Subject: Response to Request for Additional Information on Individual
Plant Examination Submittal, Davis-Besse Nuclear Power Station,
Unit 1 (TAC NO. M74402)

**RESPONSE TO REQUEST FOR ADDITIONAL INFORMATION
FOR THE IPE PROGRAM
DAVIS-BESSE NUCLEAR POWER STATION**

Figure 5-9. Logic for Failure of CET Event C—Core Debris Fails to be Cooled Ex-Vessel (page 1 of 3)

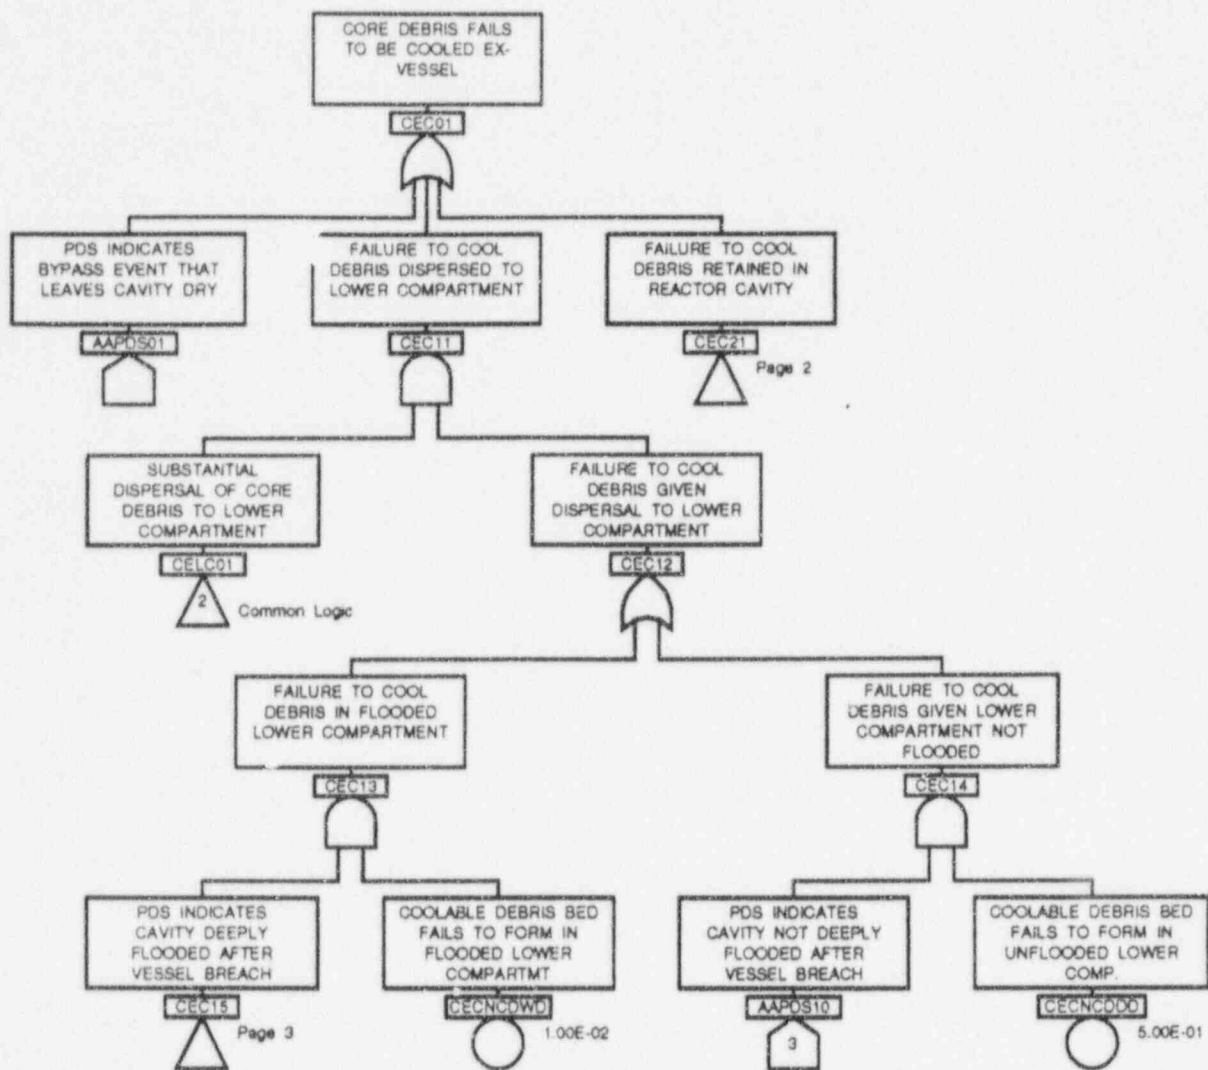
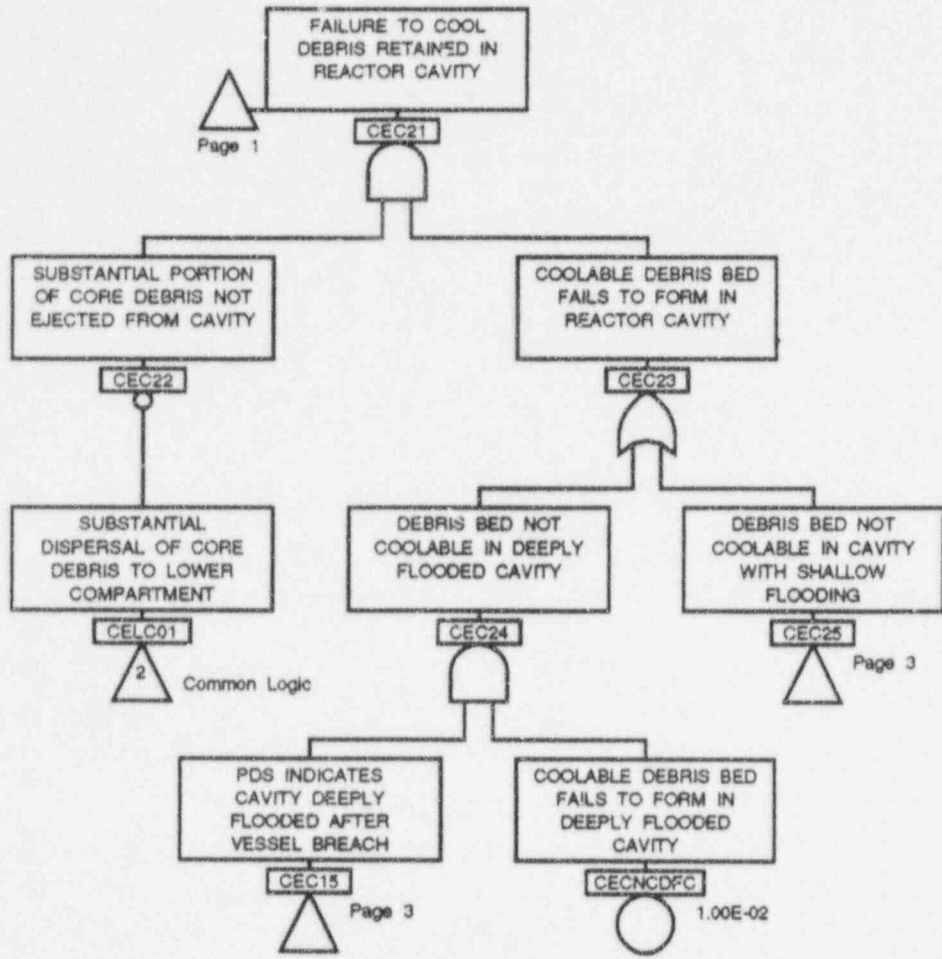
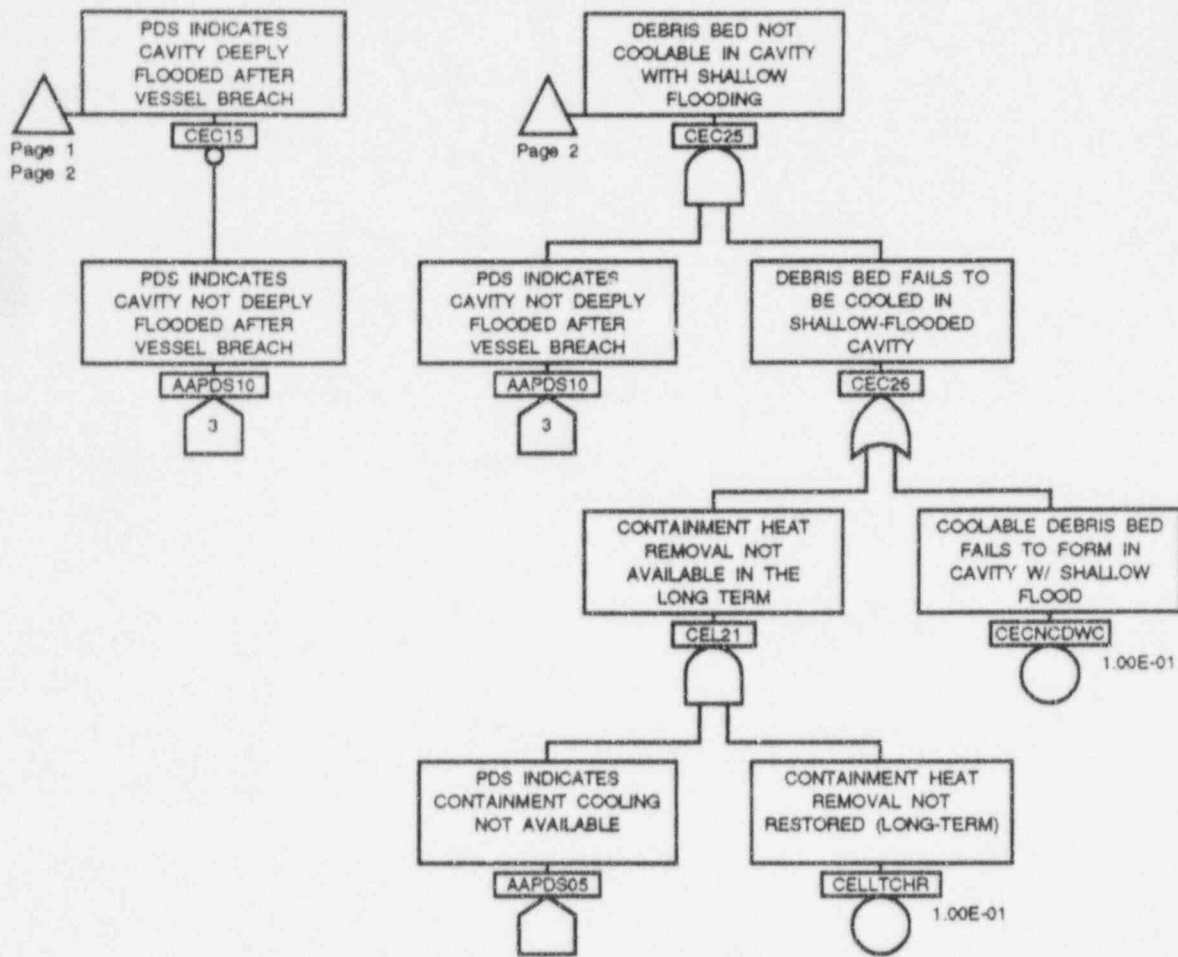
13. Davis-Besse uses a steel containment vessel and a reinforced concrete shield building, both of which are supported on a concrete foundation. The minimum basemat thickness is specified in Table 1-6 of IPE submittal Part 4 as 5.7 ft. This seems to be the thickness between the bottom of the normal containment sump and the base of the containment shield building. The thickness between the bottom of the sump and the containment steel shell appears to be significantly smaller. Please provide this thickness. Please explain how this (apparently) rather thin concrete layer was treated in your evaluation of the probability of basemat melt-through. Presumably, once the steel shell is penetrated, some release will occur even if the shield building foundation has not been completely penetrated. The discussion should address the possibility that a large coherent mass released from the RPV may stay in a clump, spread slowly, and produce a large amount of localized core concrete interaction (CCI). Please also describe how your evaluation of

the probability of a coolable debris forming in the reactor cavity took this kind of scenario into consideration. Figures 1-12 and 1-14 show other locations where the distance from the cavity floor to the steel shell appears to be small, e.g., at the first bend of the incore instrumentation tunnel. How were these other areas considered in your evaluation of basemat melt-through? If they were not considered, please justify their omission.

The precise location of a potential melt-through of the containment basemat was not critical to evaluating the possibility for this occurrence in the containment event tree. As discussed in Part 4 Section 5.2.6 and associated Figure 5-9 (see Attachment 4), core debris in the cavity region is assumed to result in basemat failure if a coolable debris bed is not formed. The different weighting factors for the associated logic are primarily dependent on the degree of cavity flooding. While the potential depth of the corium was a factor taken into consideration when assigning the respective weighting factors, the exact location was not considered to be a primary consideration (i.e., if the debris is not coolable, whatever depth of concrete is present will eventually be penetrated by ablation).
